DESIGN ADVISORY BOARD Tuesday, August 11, 2015 at 3:00 PM Conference Room 12, City Hall, Burlington, VT

MEMORANDUM

To: The Design Advisory Board
From: Mary O'Neil, AICP, Senior Planner
RE: 6 & 8 Proctor Place; ZP16-0020CA
Date: August 11, 2015

Request: Renovation of 6 Proctor Place, including a small rear addition and new fiberglass windows.

OPTION 1

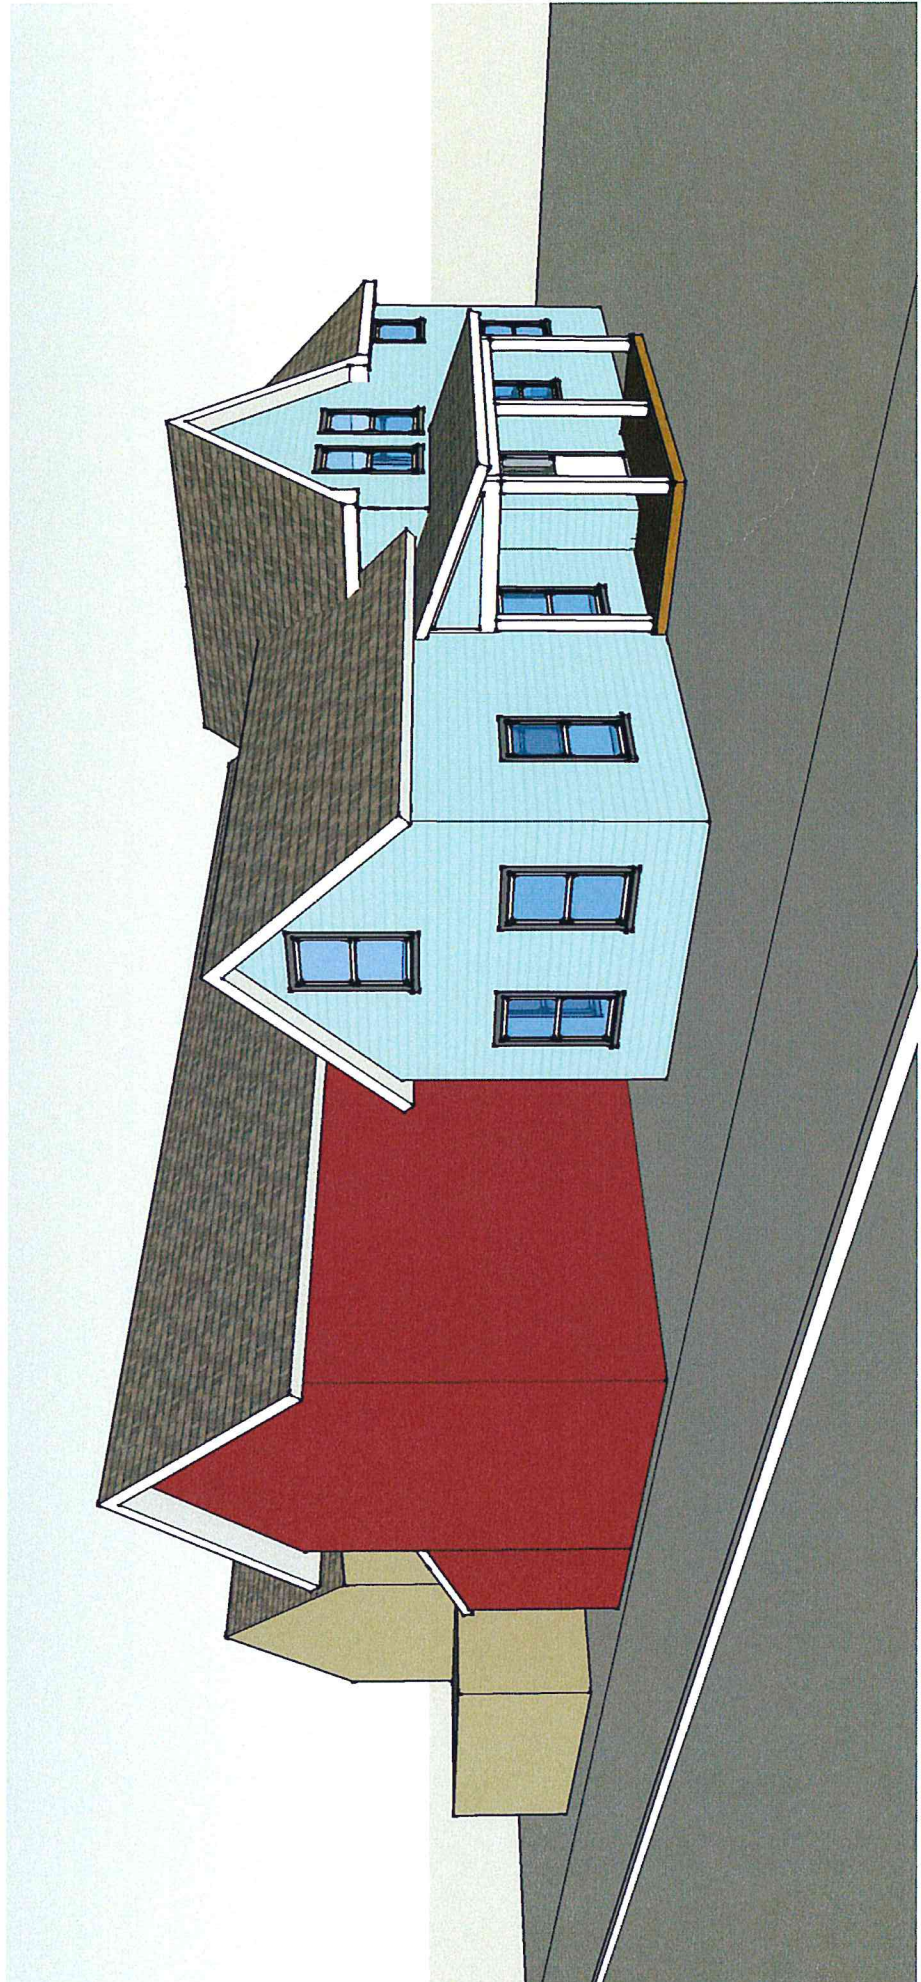
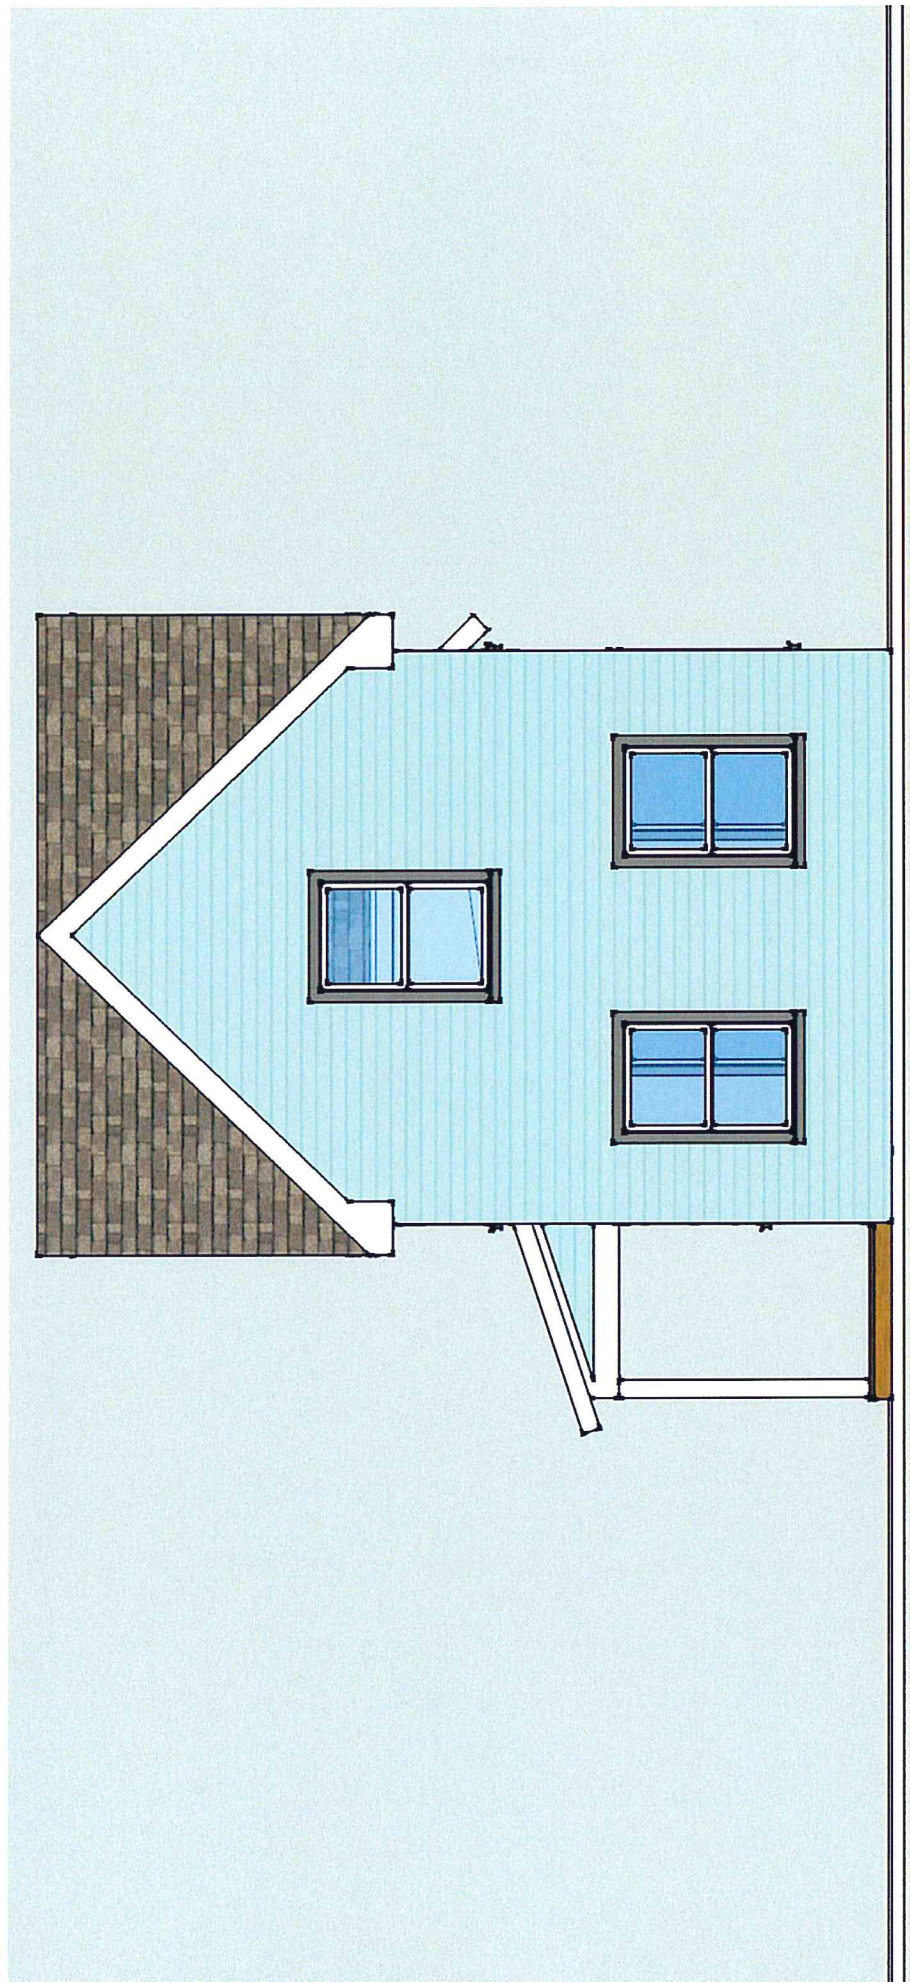
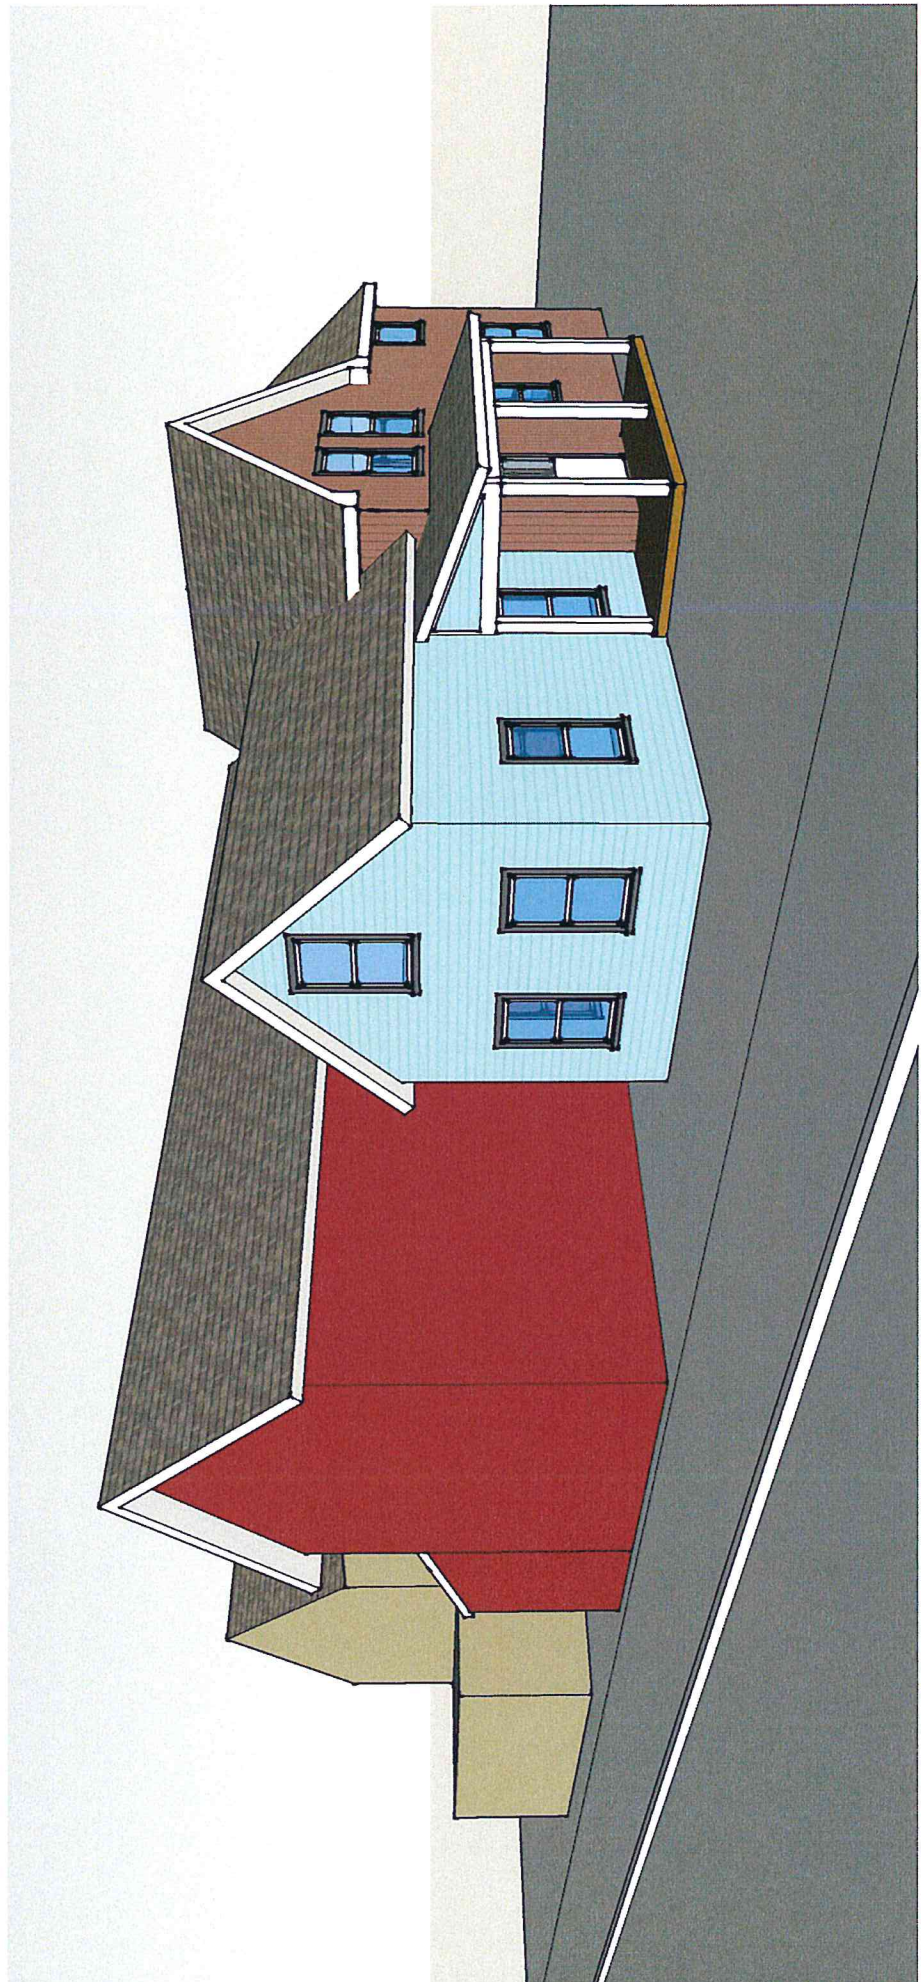
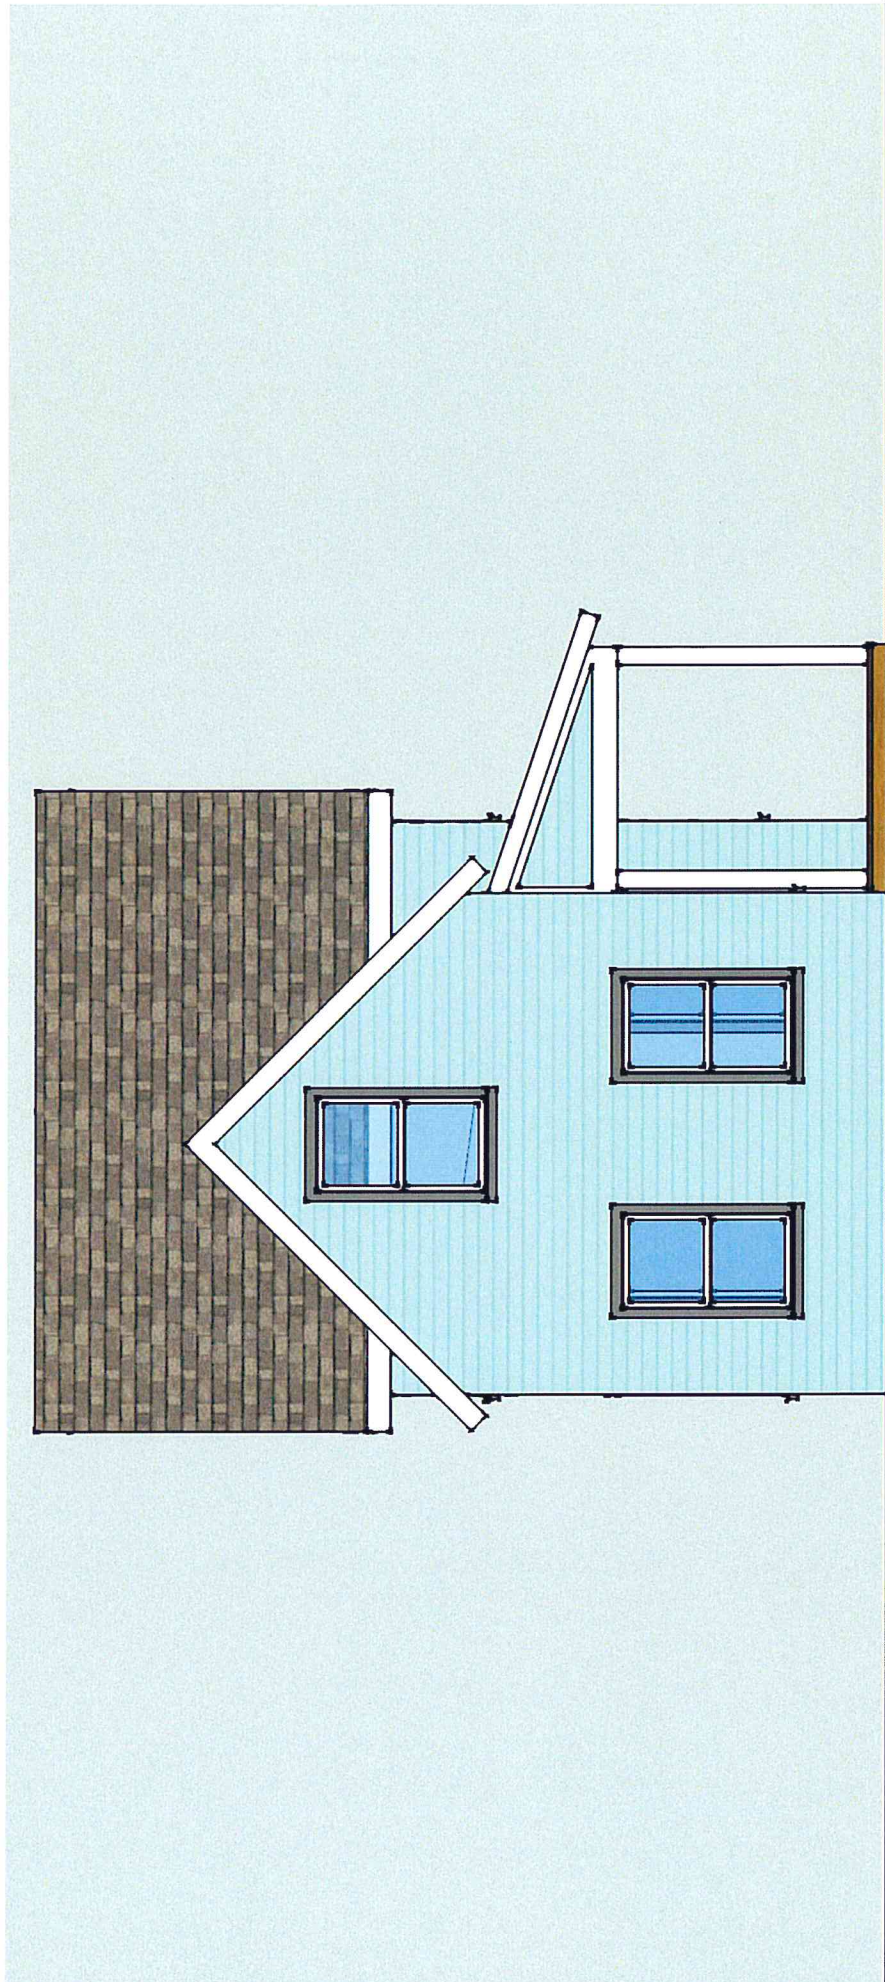
The addition is proposed to replace a single story addition at the rear with a two story structure. Although oriented behind the primary structure as is typical of many residential additions, it is proportionally much larger than the existing structure. Option 2 (with a cross-gable) helps to ameliorate the difference in scale.

Revised elevations give an enhanced image of the proposed addition, drawn professionally to better illustrate scale and proportion. Option 1 is similar to the original proposal, but Option 2 presents a cross gable plan that would provide a similar amount of new habitable area while diminishing the visual impact of the abrupt roof height proposed for the rear. It also reflects a continued eave line on the rear that more closely associates with the front part of the building. These are visual tricks that soften what might be a brusque change in massing and scale, and make clear the progression of

The principle building will remain, but the key is to minimize the visual impact of the larger rear addition. Two options have been provided; both will enhance to livability of the residence. The roof plan illustrated in Option 2 is more successful in minimizing that sudden disparity between the small size of the principle mass with the new addition.
